UNITED STATES PATENT AND TRADEMARK OFFICE

10/593,021

Reiner Schmitt

DETAILED ACTION

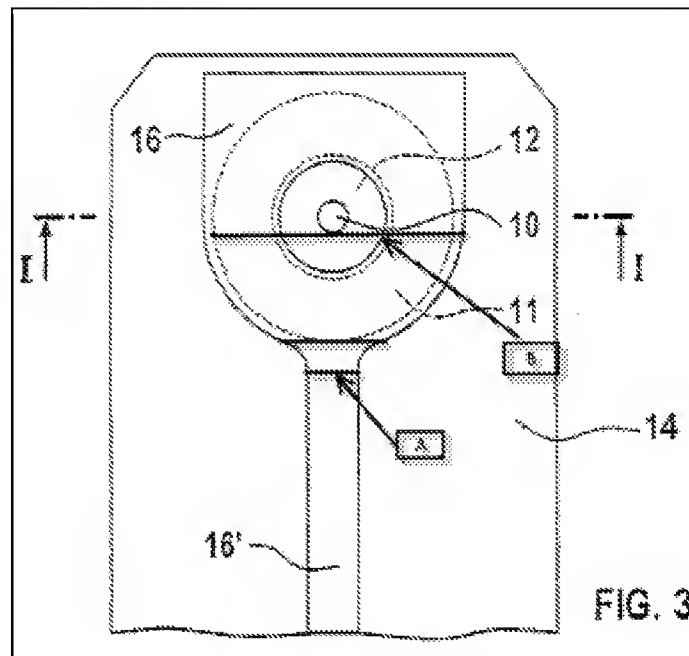
8. Claims 28-31, 38-40, 42 and 52-54 are rejected under 35 U.S.C. 102(b) as being anticipated by Scheer et al. (US 2003/0019279).

Addressing claims 28-30, Scheer discloses a sensor element (figures 1-3) for detecting a gas component in a measuring gas, comprising:

A conductor track 16 applied to the solid electrolyte, wherein the conductor track includes an electrode 16 situated in a measuring area of the sensor element and an electrode lead 16' connected to the electrode and situated in a lead area of the sensor element, and wherein the conductor track has a narrowing in a transition area between the measuring area and the lead area (please see inserted figure 3 below, the portion between the two solid lines is the claimed narrowing); and

With regard to claim 29, the conductor track is formed as one layer; therefore, the thickness of uniform. Thus, the cross-sectional area is determined by the width of the conductor track, in the figure above, the width of the area of the narrowing is smaller than the width of the electrode area; therefore, the cross sectional area of the area of the narrowing is smaller than the width of the electrode area. Furthermore, a smaller cross-sectional area also reduces the heat conduction along the conductor track from the measuring area to the lead area as required by claim 30.

With regard to claims 31 and 38-39, in the inserted figure 3 above, the width along line A is less than 70% of the width at line B; therefore, the cross sectional area at line A is also less than 70% of the cross sectional area at line B.

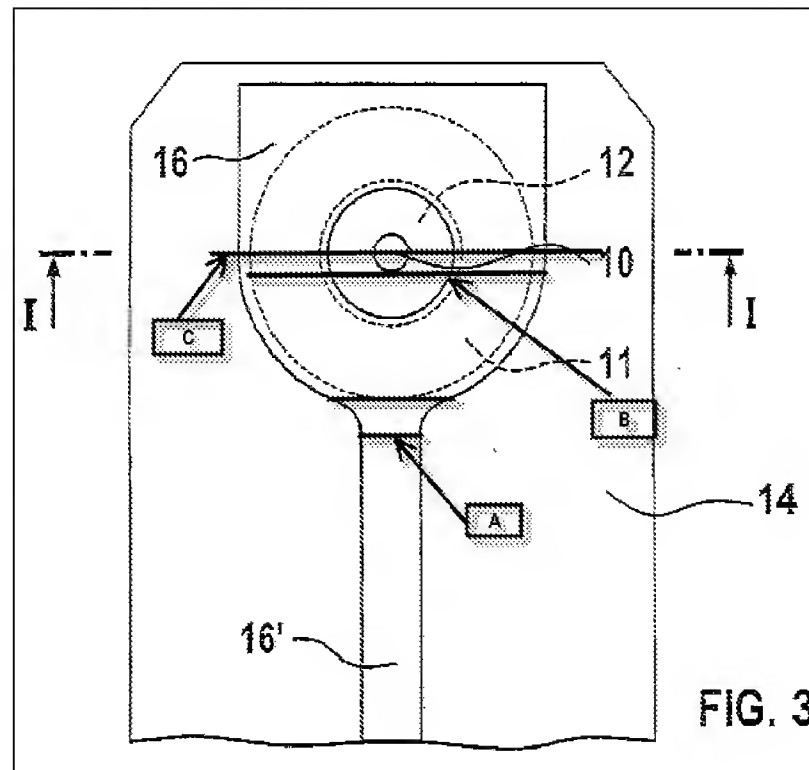
Addressing claim 40, in figure 1, 14 is the first solid electrolyte sheet and 7 is the second solid electrolyte sheet with the conductor track 15, which has the same shape as conductor track 16 [0053], situated in a layer plane between the two solid electrolyte sheets.

A second electrochemical cell including a third electrode 13 and a fourth electrode 8 connected via a solid electrolyte 7, a reference gas chamber 6, and wherein the narrowing of the conductor track encompasses the third electrode 13 and the third lead (figure 1, [0060], the third electrode has the same shape as electrodes 15 and 16).

Addressing claims 52 and 54, in inserted figure 3 below, the portion of electrode 16 above the line C is the second electrode section that is electrically connected to the first electrode section (section below the line C, between the above indicated transition area and the second electrode section), which is connected to the electrode lead 16' in the transition area between the measuring area and the lead area, only on their sides facing away from the lead area.

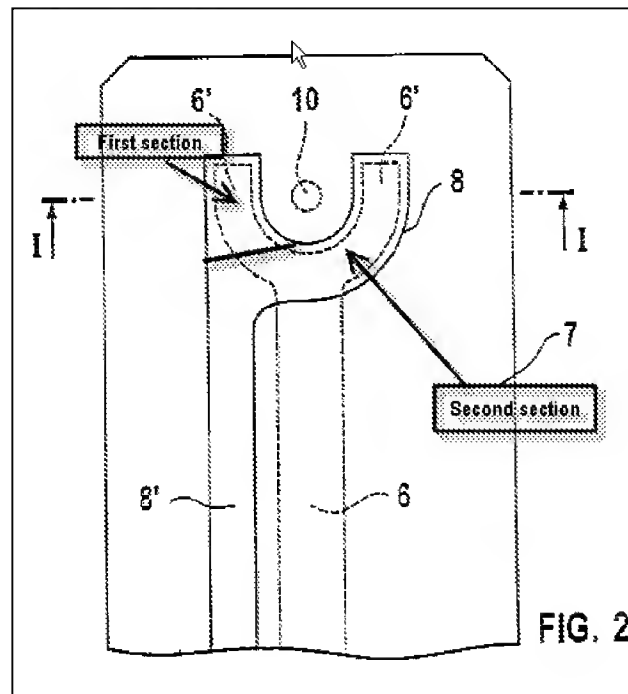
In the alternative, the electrode of the conductor track 8 also includes a first electrode section connected to the electrode lead 8' in a transition area between the measuring area and the lead area and a second electrode section that is connected to the first electrode section only on their sides facing away from the lead area as indicated below.

Addressing claim 53, in the figure 2 above, the second electrode section has an annular shape, and a side of the second electrode section facing the lead area has a recess in which the first electrode section is situated (from the inserted figure 2 above, the space between the two sides of the second electrode section where first section resides is the claimed recess).

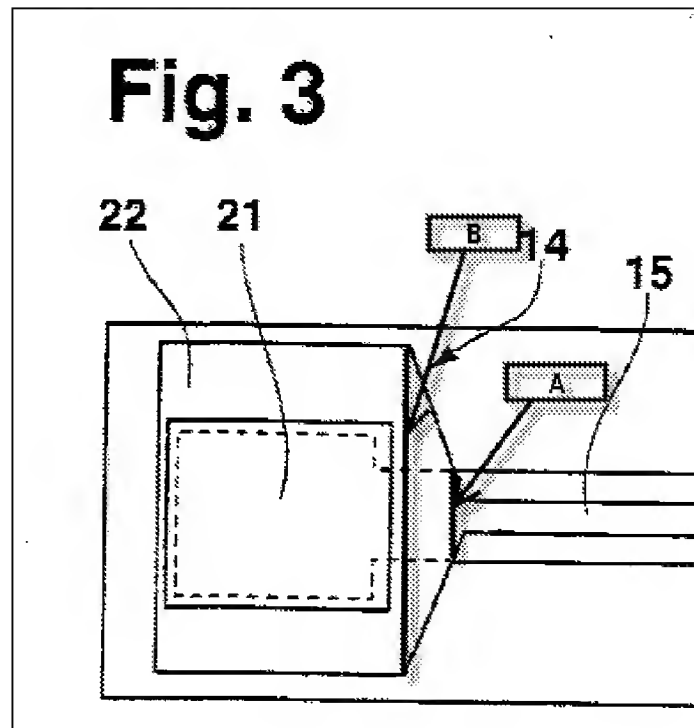
A conductor track (22+15) applied to the solid electrolyte, wherein the conductor track includes an electrode 22 situated in a measuring area of the sensor element and an electrode lead 15 connected to the electrode and situated in the lead area, and wherein the conductor track has a narrowing in a transition area between the measuring area and the lead area (please see figures 1-3).

Suzuki discloses a gas sensor comprises a heater element 19 (figure 1).

With respect to the limitation of claim 29, since the portions 22 and 15 are applied as one conductive layer; therefore, the conductive layer must have uniform thickness. Thus, the cross sectional area is determined by the width of the conductive layer. In figures 1 and 3, the width of the narrowing is smaller than the first area 22 of the conductor track adjacent to the narrowing; therefore, the cross-sectional area of the area of narrowing is smaller than the cross-sectional area of the portion 22. Furthermore, a smaller cross-sectional area also reduces the heat conduction along the conductor track from the measuring area to the lead area as required by claim 30.

Addressing claims 31 and 38-39, in the inserted figure 3 below, the cross sectional area along line A of the narrowing is less than 70% of the cross sectional area along line B of the first area of the conductor track adjacent to the narrowing.

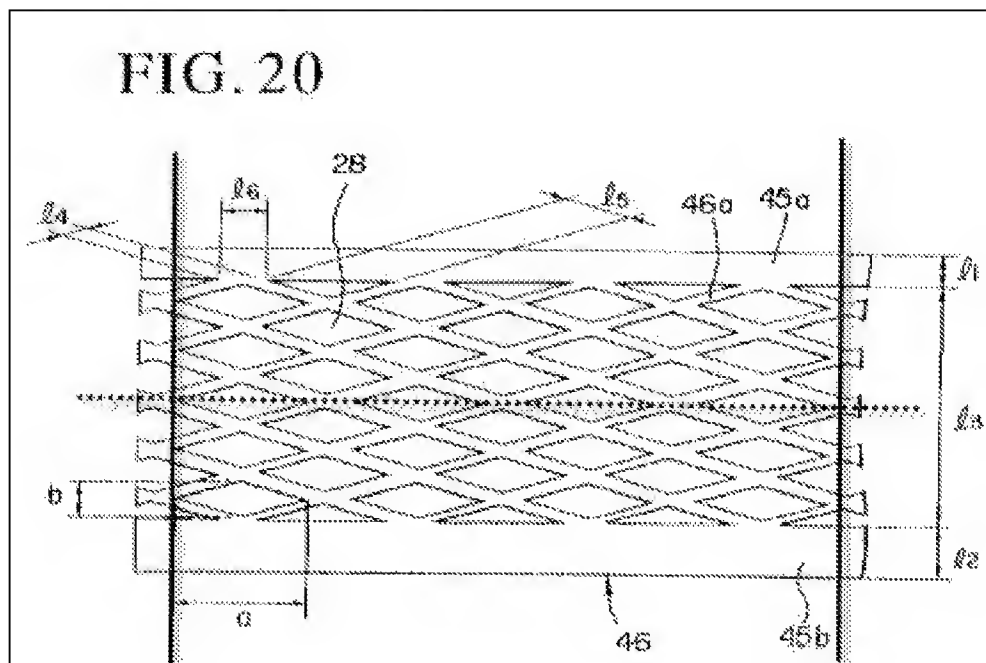
Toyao discloses a honeycomb filter for catalytic converter of an automobile comprises conductive plate 46 (figures 19-20, 5:46-53) having areas 45a and 45b with a narrowing portion therebetween (figure 20 reproduced below). Furthermore, the narrowing portion comprises a plurality of slits 46a and the disclosed dimensions in col. 12 lines 12-34.

From the picture above, the width of the conductor track 46 between the two solid lines is $b = 4a + 3l_6$ and the cross sectional area of the conductor track along the dotted line is $A = 3(l_6 * \text{thickness})$. Furthermore, the thickness of the conductor track 46 is 0.03-0.05 mm (12:30-34). The parameter a is calculated based on the fact that the slit 46a is a rhombus with the parameter $b = 0.4$ mm and $l_5 = 45$ mm; therefore, $a = 90$ mm. From the calculation above, the width $b = 4a + 3l_6 = 375$ mm and the cross section area is $A = 3(l_6 * 0.05 \text{ mm}) = 0.75 \text{ mm}^2$; therefore, the ratio A/b is $.75/375$ or 0.002 mm.

At the time of the invention, one with ordinary skill in the art would have found it obvious to modify the narrowing portion of the conductor track of Diehl with the slits of the conductor track disclosed by Toyao because the slits reduces power consumption in raising the temperature of the conductor track as well as reduce the heat conduction between the areas 45a and 45b (Toyao, 2:23-54). Therefore, in the modified gas sensor

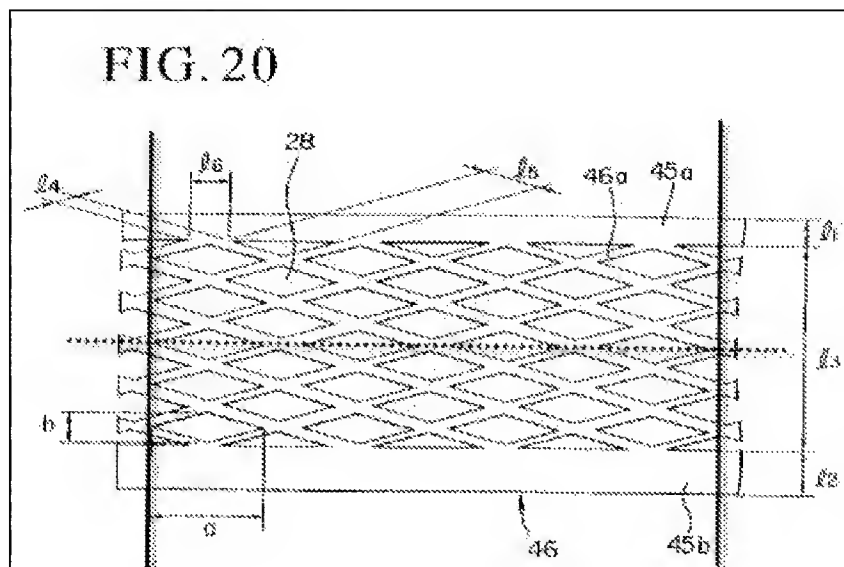
Addressing claims 33-36, the slits 46a of Toyao (figure 20) are the claimed slot-shaped recesses having the shorter side (b) and the longer side (a) that is perpendicular to the longitudinal extension of the conductor track and approximately perpendicular to the heat gradient formed in the conductor track because the heat gradient is along the direction from 45a-45b.

Addressing claim 37, in figure 20 above, the width of the conductor track between the two solid lines is clearly greater than the sum of the width of the individual conductor track sections separated by the recesses; therefore, in light of the indefinite rejection above, the ratio of b/c is greater than 1 just like that shown in figure 5 of current application.

Toyao discloses a honeycomb filter for catalytic converter of an automobile comprises conductive plate 46 (figures 19-20, 5:46-53) having areas 45a and 45b with a narrowing portion therebetween (figure 20 reproduced below). Furthermore, the narrowing portion comprises a plurality of slits 46a and the disclosed dimensions in col. 12 lines 12-34.

From the picture above, the width of the conductor track 46 between the two solid lines is $b = 4a + 3l_6$ and the cross sectional area of the conductor track along the dotted line is $A = 3(l_6 * \text{thickness})$. Furthermore, the thickness of the conductor track 46 is 0.03-0.05 mm (12:30-34). The parameter a is calculated based on the fact that the slit 46a is a rhombus with the parameter $b = 0.4$ mm and $l_5 = 45$ mm; therefore, $a = 90$ mm. From the calculation above, the width $b = 4a + 3l_6 = 375$ mm and the cross section area is $A = 3(l_6 * 0.05 \text{ mm}) = 0.75 \text{ mm}^2$; therefore, the ratio A/b is $.75/375$ or 0.002 mm.

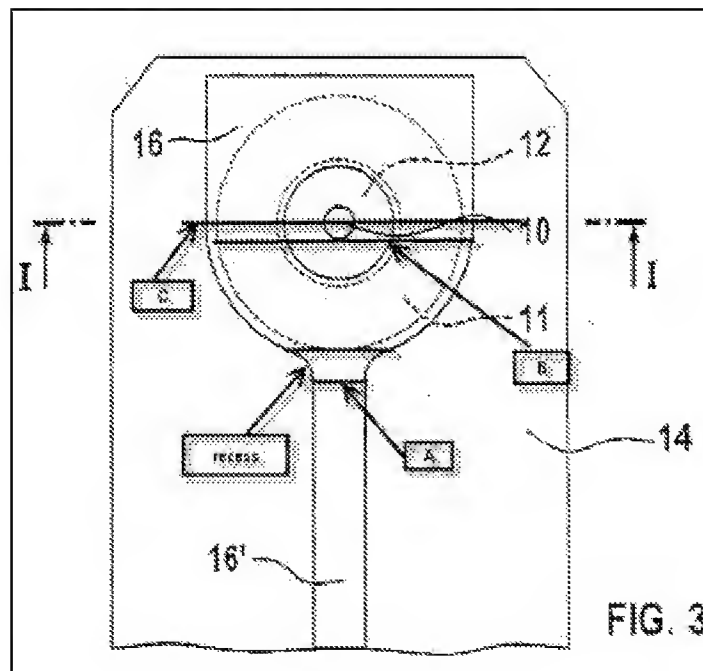
Scheer '699 discloses a gas sensor; wherein, the reference electrode is disposed in the same plane of stratification as the measuring area (figure 1); furthermore, the reference chamber is also filled with porous material 32. Additionally, the electrode lead of the electrode is covered by an electrically insulating layer to insulate the electrode lead from the solid electrolyte (3:35-49).

'699 because the insulating layer would electrically insulate and protect the electrode lead and the gas reference chamber provided in the same plane of stratification as the measuring area reduces the in-coupling of the first electrode and the third electrode and thus the lambda value ripple (Scheer '699, 3:35-4:5). In the modified gas sensor of Scheer, the narrowing portion of the conductor track 13 is between the fourth electrode 8 that is provided in the reference gas chamber that is in the same plane of stratification as the measuring area. Furthermore, the insulating layer of the lead for the electrode 13 would electrically insulate and shield the fourth electrode 8 from the heater element.
